Point Beach Nuclear Plant, Units 1 and 2
Dockets 50-266 and 50-301
License Nos. DPR-24 and DPR-27

Clarification to Information Regarding the Point Beach Nuclear Plant
License Renewal Application
(TAC Nos. MC2099 and MC2100)

CLARIFICATION TO INFORMATION REGARDING POINT BEACH NUCLEAR PLANT, UNITS 1 AND 2 LICENSE RENEWAL APPLICATION

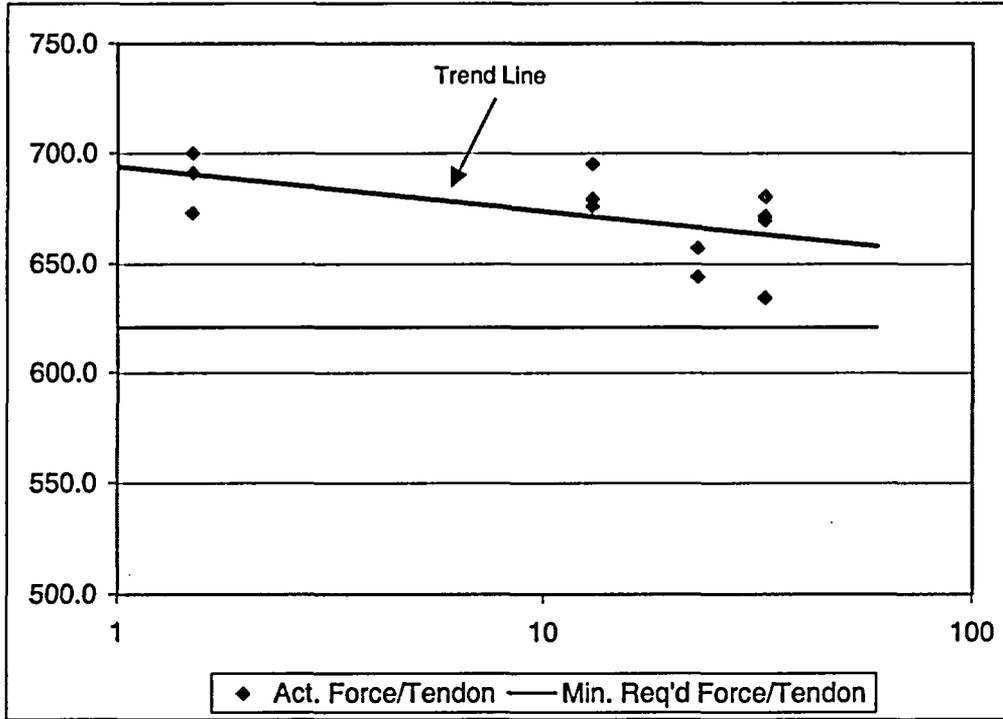
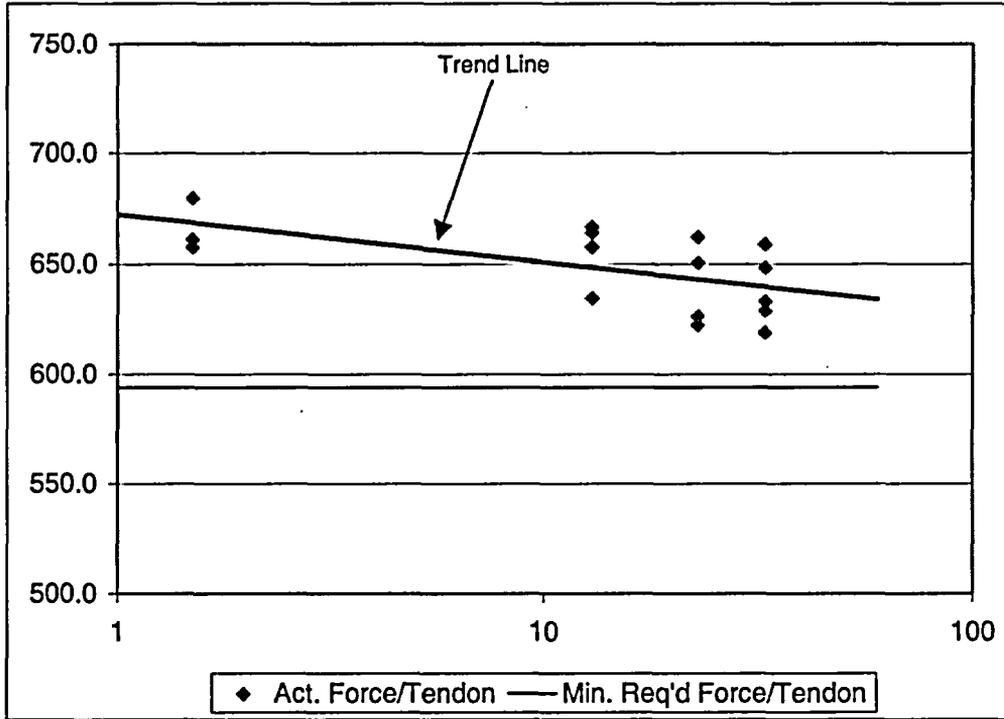
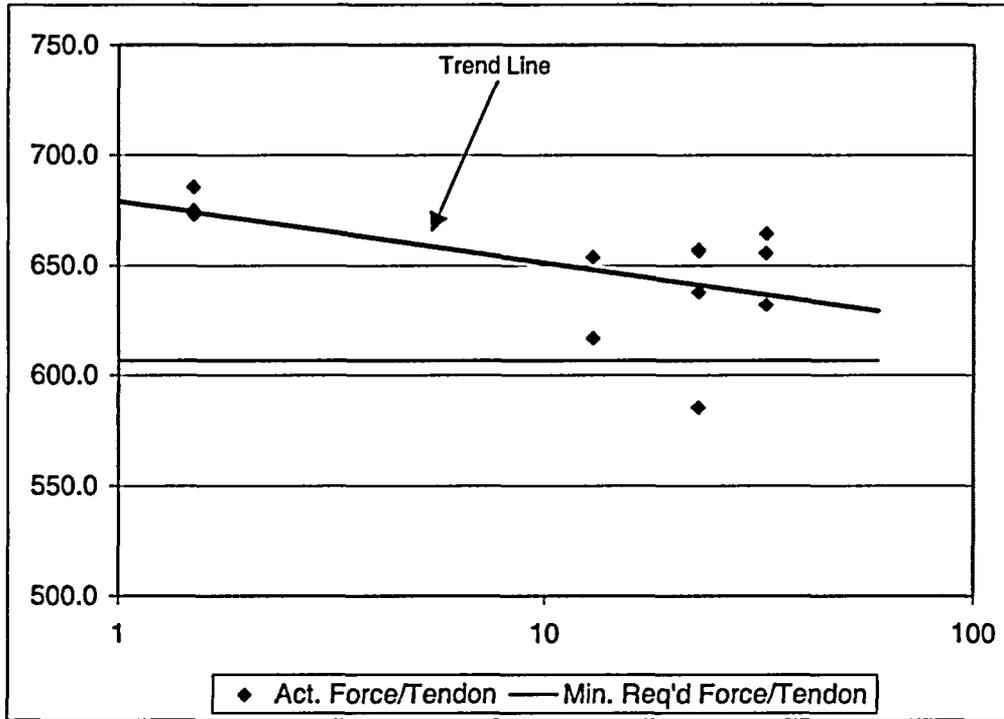
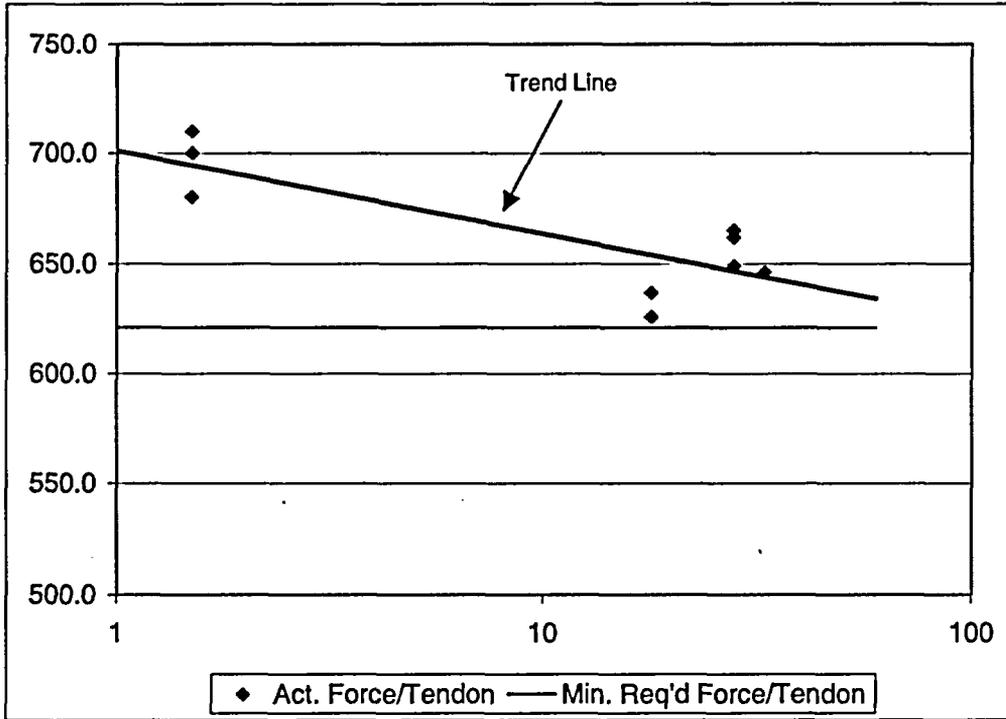
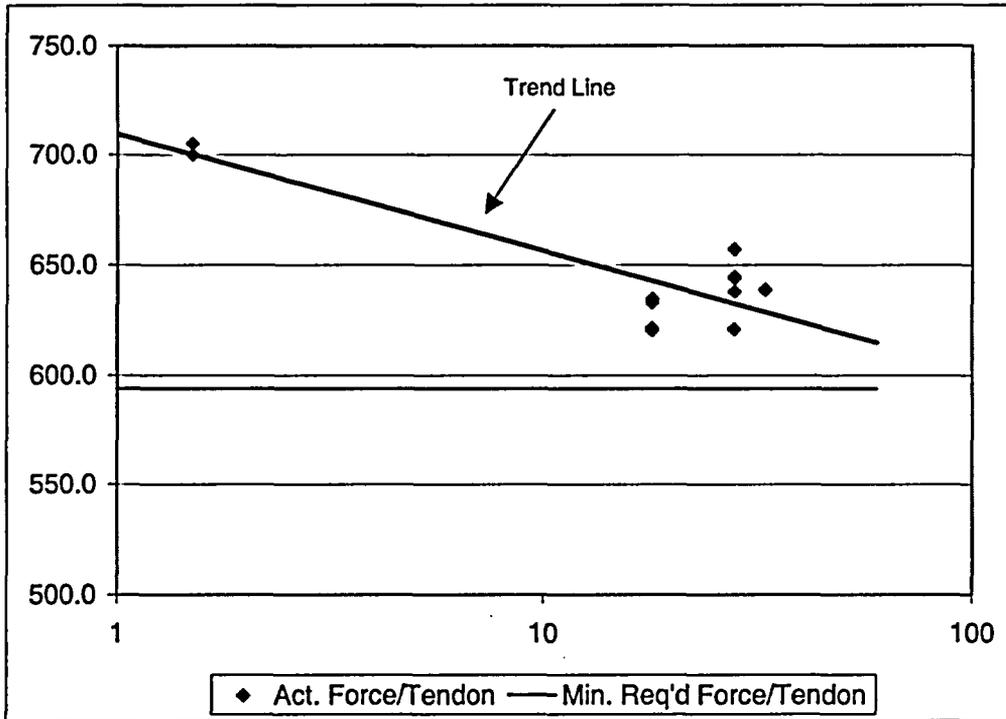
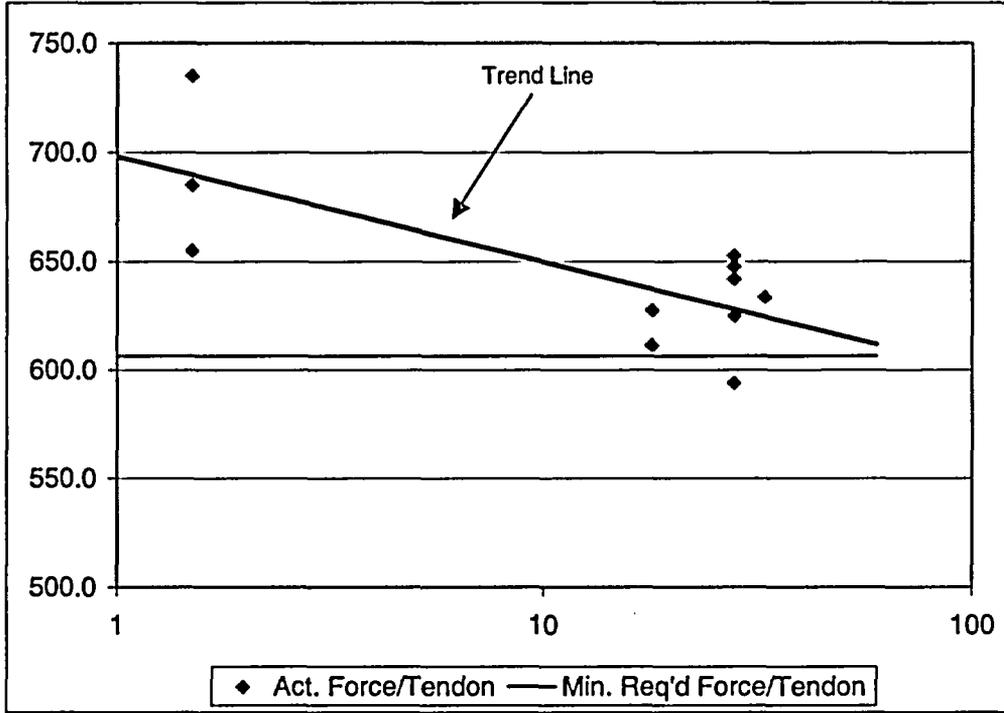
The use of 10 CFR 54.21(c)(1)(ii) and (iii) is appropriate for concrete containment tendon prestress TLAA. However, the staff need to assess the plant specific operating experience regarding the residual prestressing forces in the containments and the methods used to arrive at the projected prestress forces. Based on the analysis performed as per 10 CFR 54.21(c)(1)(ii), the applicant is requested to provide the following information:

- a. The estimated upper and lower bound lines, and the minimum required prestressing forces for each group of tendons for each containment.
- b. Trend lines of the projected prestressing forces for each group of tendons based on the regression analysis of the measured prestressing forces (see NRC Information Notice 99-10 for more information). Also, show the actual measured prestressing forces that were used to obtain the trend lines.
- c. Plots showing comparisons of prestressing forces projected to 40 years and 60 years with the minimum required prestress (or MRV) for each group of tendons for each containment.

The specific request from the NRC staff was to re-title the graphs and edit the legend for the projected pre-stressing force trend line graphs (reference RAI 4.5-1(b)). The information should be presented on a per tendon group basis. There are six graphs total, one for each group of tendons for the two units. The graphs follow:
